HUNGERFORD TOWN COUNCIL

MINUTES of the **Environment and Planning Committee** meeting held on Monday 14th July 2025 at 7.00 pm in the Library, Church Street, Hungerford.

- a) **Ref:** 25/01203/FULMAJ - **Receive presentation from Aldi representatives**
Applicant: Land Adjacent To Herongate Leisure Centre Herongate Hungerford
Proposal: The erection of a 1725 sqm (gross) Class E discount food store with associated access, parking and servicing areas, landscaping, together with highways improvements at the junction of the A4 (Charnham Street) and the B4192.
Link: [Planning Documents \(westberks.gov.uk\)](http://Planning Documents (westberks.gov.uk))

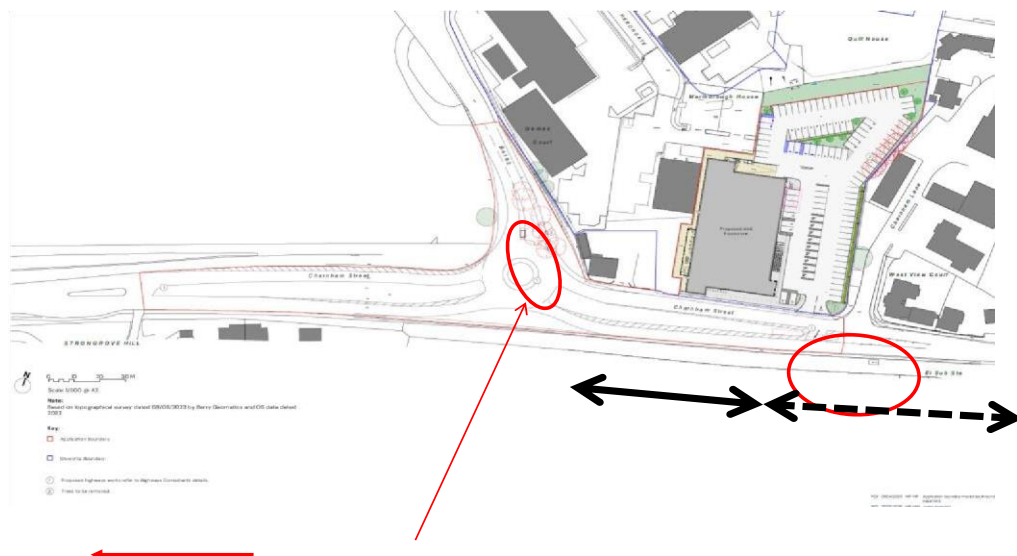
Cllr Cole presented the list of questions and comments from the meeting in June: •

- *Net loss of habitat – They will have to buy in offsite to meet the requirement. This can and should be done locally, should be discussed with the Town and Manor re Wetlands Project etc. • Proximity to SSSI and potential impacts on it*

- *The planning condition referenced in the Archaeological report – HTC feels this should be emphasised and conducted.*
- *Trees along Eastern border being removed will expose neighbouring office.*

- *The trees being removed are not being replaced in sufficient numbers or of sufficient size to ensure adequate cover quickly enough*
- *Need more screening to the west side of the plot, in particular Undy's*

- *Landscape management plan is insufficient – The 12-month period specified needs to be increased to 5 years.*
- *Roof is only part filled with solar panels – need to maximise the amount of solar energy generated.*

- *Concern over proposed entry and exit arrangements from site and proximity to Charnham Lane. The proposed arrangement may cause tailbacks. Is there an option to do the roundabout differently?*

- *Potential Traffic disruption – given the recent "history" over the A4 closure at Speen, HTC hopes that this will be well planned.*
- *[Any impact on the local school, Oaklands, needs to be understood]*

- *Need for pedestrian crossing. Narrow footway by the Bear will become more congested.*

- a) It is only about 10m between the centre lines of the site and Charnham Lane priority junctions. This is a serious problem as traffic leaving the site will block visibility to Charnham Lane traffic and visa versa. Also left turning traffic indicating to go into Charnham Lane will confuse traffic exiting the site access. Junctions should generally be at least the distance of the required visibility and in this case 43m.
- b) The set back give way line – needs to be in line with the kerb edge.
- c) A 2m footway is required between Charnham Lane and site access.
- d) Where is the Stage 1 Road Safety Audit for the junction?

- a) Generally support and will be a major safety enhancement to the town
- b) Needs to be designed up in more detail with white lines and signs so we can understand the speed limit changes etc
- c) Would recommend the 5.0m and 5.5m entries be widened to 6.0m so 2 lanes can be marked out. Gives more flexibility for higher flows such as during M4 closures.
- d) Where is Stage 1 RSA?

Resolution: Hungerford Town Council supports this planning application (AIF with one abstention) subject to WBC resolving the following issues listed below. Cllrs agreed the following statement for HTC's decision on WBC's Planning Portal in support of the application subject to resolving the Highways concerns raised:

- It is only about 10m between the centre lines of the site access and Charnham Lane priority junctions. This is a serious problem as traffic leaving the site will block visibility to Charnham Lane traffic and visa versa. Also left turning traffic indicating to going to Charnham Lane will confuse traffic exiting the site access. Junctions should generally be at least the distance of the required visibility and in this case 43m.

- The set back give way line – needs to be in line with the kerb edge
- A 2m footway is required between Charnham Lane and site access and a safe pedestrian crossing with lowered kerbs for pedestrians across the site access.
- Where is the Stage 1 Road Safety Audit for the junction?

- Generally support and will be a major safety enhancement to the town
- Needs to be designed in more detail to include signage and white lines to fully understand new road layout and new speed limits on approaches.
- Would recommend the 5.0m and 5.5m entries be widened to 6.0m so 2 lanes can be marked out. This gives more flexibility for higher flows such as when with M4 closures.
- Where is the Stage 1 RSA?

- Possible relocation of access point on Charnham Street.
- Set up an agreed delivery strategy, which may involve diverting deliveries to enter the store via Charnham Park ... see point 4 to enable

Introduce double yellow lines on Charnham Street between the BMW garage and the proposed roundabout and along the length of Charnham Park.

A pedestrian crossing needs to be provided on Charnham Street somewhere between the BMW garage and the site, either a Zebra or Puffin. Required to allow a safe pedestrian route for pedestrians to the site between the town centre and residents of Bearwater.
